Subject: Submittal of Revisions to the Quality Assurance Plan for Shipping Program

### Description of Changes – Quality Assurance Program, Revision 22

### Description of Changes – Quality Assurance Program, Revision 23

# Quality Assurance Plan For Shipping Program

Figure 1.1.1

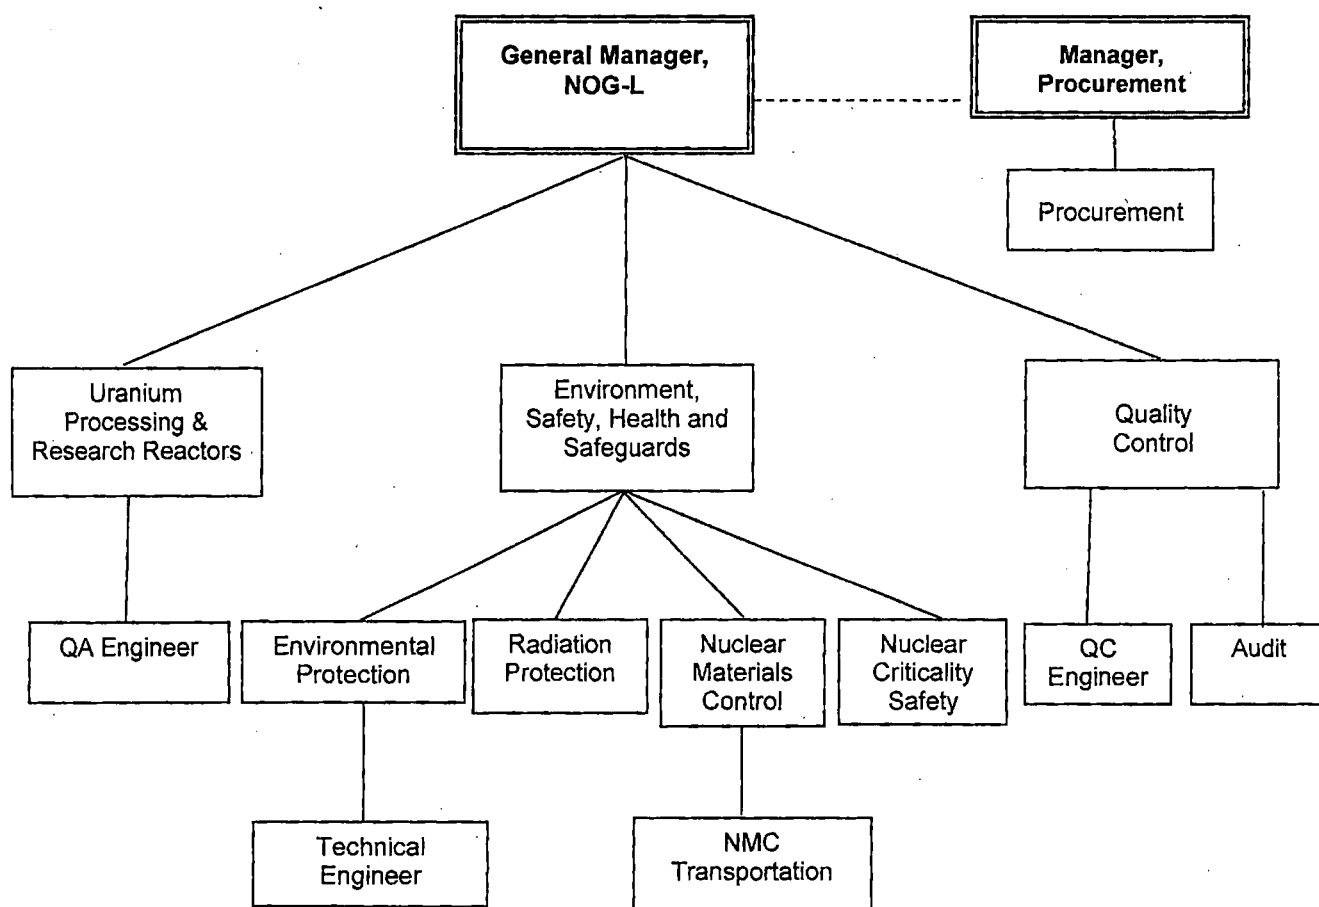
Section	Description of Change
Entire Document	Changed "Accountability Operations" to "Transportation".
Entire Document	Changed "Approved Supplier List" to "Composite Supplier List".
Figure 1.1.1	Added Audit group to the Figure.
